Urgent: Field Safety Notification FSN20149997

Follow-up action for the Application Instrument of Sternal ZipFix™: Changes in the Surgical Technique Guide

Part Description	Part Numbers	Lot numbers
Application Instrument for Sternal ZipFix™	03.501.080	All 1st generation Application Instruments (Lots prior to 8100630)

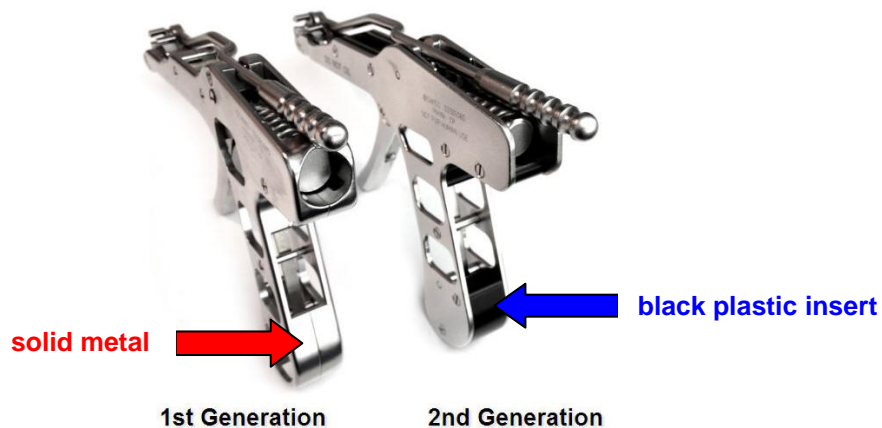
Reason for notification: While the Surgical Technique Guide includes a precaution that the trigger must be released before and during cutting and that no cutting should take place under tension, when using the 1st generation Application Instrument for Sternal ZipFix™, it is possible to cut the implant while the tensioning trigger is being squeezed (known as being cut under tension). This allows the ZipFix™ implants to become overly tensioned and possibly cut.

NOTE: This issue applies to the 1st generation Application Instrument only. The 1st generation instrument is distinguishable by the presence of an all stainless steel handle. Please see the figures below for 1st generation and 2nd generation instruments.

If you currently have a 1st generation ZipFix™ Application Instrument you **must** completely release the tensioning trigger before cutting the implant. Additionally, after cutting the implant, return the cutting lever to its originating (locked) position before using the Application Instrument to tension a subsequent implant.

Table 1: Updated version of the Surgical Technique Guide (036.000.285 AE) gives precise instructions how to avoid cutting the implant while tensioning with the application instrument .

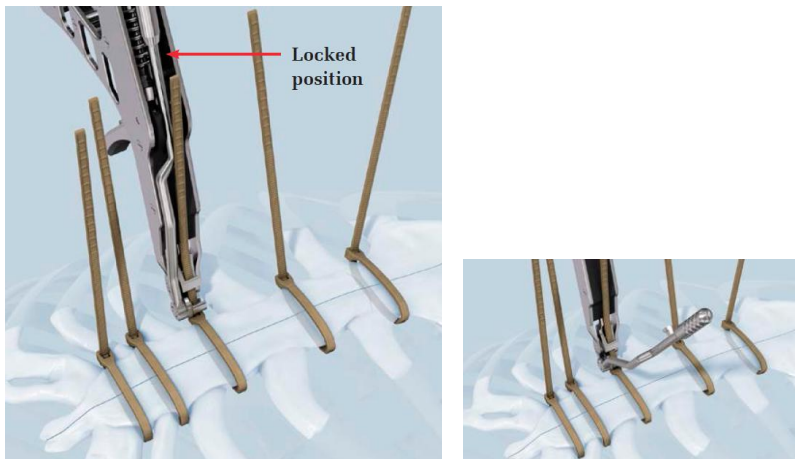
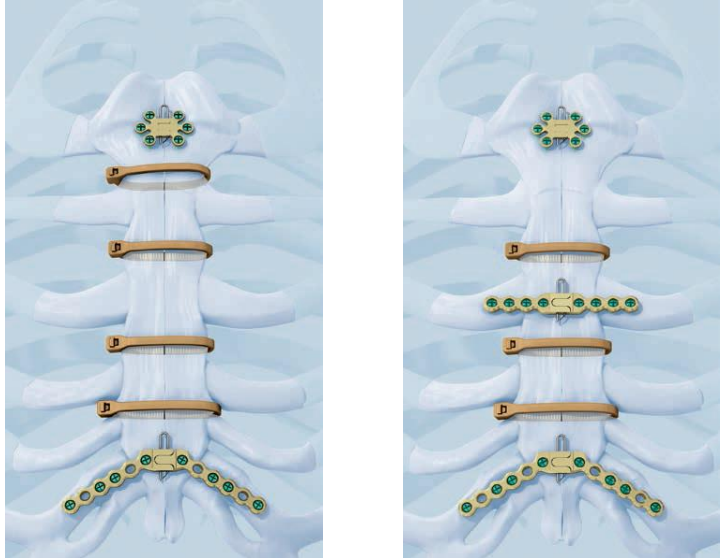
Table 1 Updated Surgical Technique Guide on Sternal ZipFix™			
New version		Former version	
Version: 036.000.285 AE Date: 03/2014	page	Version: 036.001.285 AD Date: 10/2012	page
Part: Surgical Technique Chapter: Surgical Technique Section: 7 Remove excess material This chapter is newly constructed to ensure how to avoid cutting under tension. Newly added wording: “Warning: The tensioning trigger must be completely released before and during implant cutting. Cutting the implant while tensioning with the application instrument could compromise the implant lock and lead to implant failure. Do not cut the implant under tension. ...The excess material can also be removed with a wire/pin cutter.”	14	“Ensure the cutting lever is in the locked position. Precaution: The trigger must be released before and during cutting. Do not cut under tension.”	14
New: Detailed images show the position of the cutting lever locked and unlocked. An arrow indicates “Locked position” . 	14		14

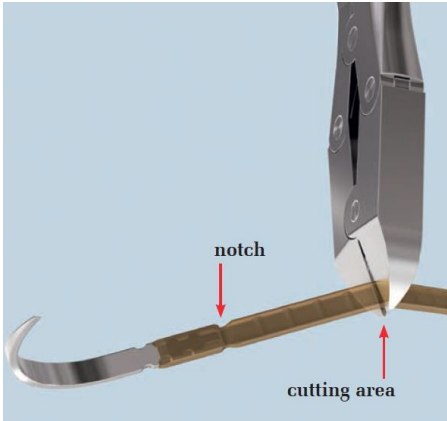
Table 1 Updated Surgical Technique Guide on Sternal ZipFix™			
New version		Former version	
<p>New: Overview illustrations provide orientation of the correct positioning of the cutting lever.</p> 	13	<p>Comment: The former image didn't present the cutting lever in full size, this has been changed in the updated version in order to give optimized orientation.</p>	12
